FCC ID: 2BAH6-SU601

SU6 Change from Rev 2 to Rev 3

PCB changes (from PCB4465-2 to PCB4465-3):

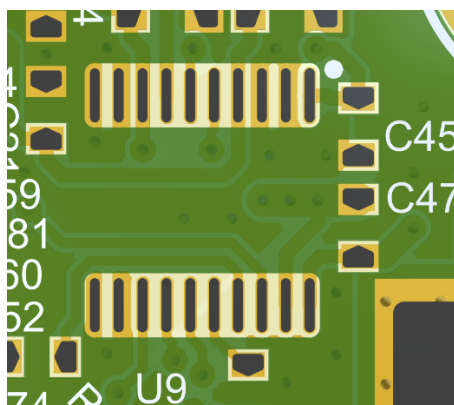
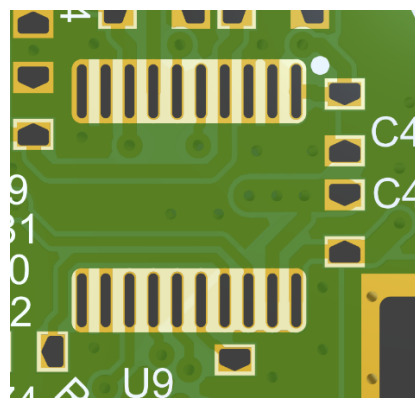
- 1) Footprint change (U9) – change in polygon pour for better SMT placement and inspection.
(U9) is an Analog to Digital converter.
No change in Radio parameters has occurred.

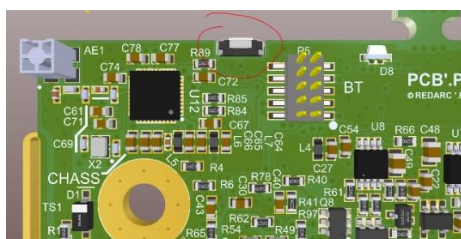
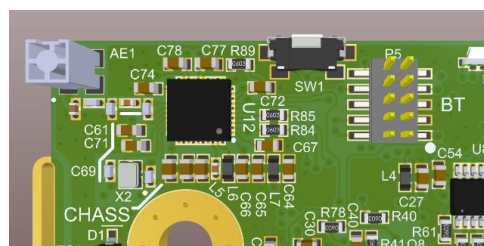
- 2) (SW1) moved to top side of PCB - for better SMT placement and soldering
No change in Radio parameters has occurred.

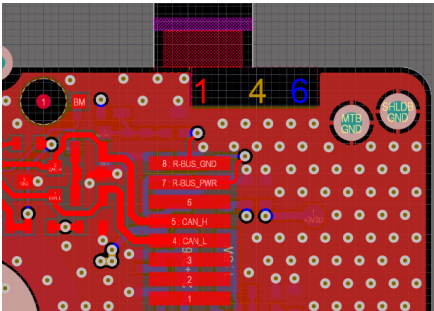
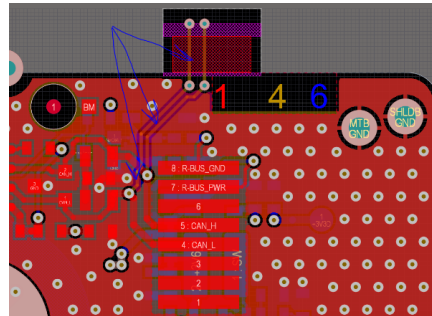
- 3) Tracks added to allow array testing, breaks out 2 interface lines to communicate to array testing and programming of multiple PCB's.
No change in Radio parameters has occurred.

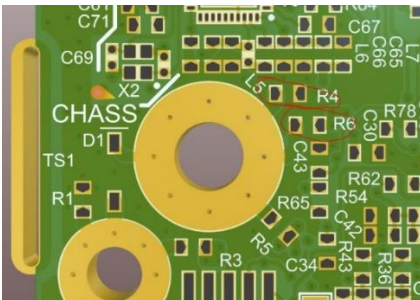
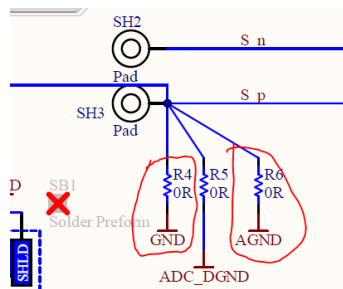
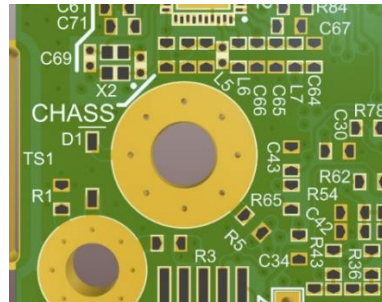
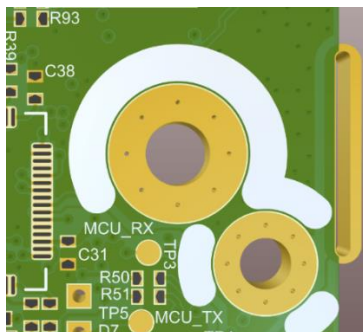
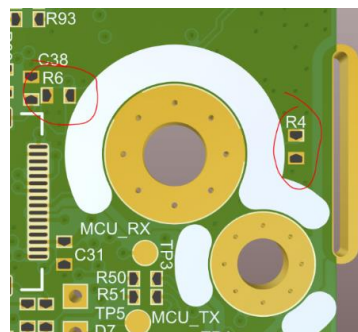
- 4) OR resistor jumpers (R4) and (R6) were moved from TOP layer to BOT layer
(R4) and (R6) connect the PCB power GND and the PCB Analog GND to the power GND terminal (SH3 pad). No change in Radio parameters has occurred.
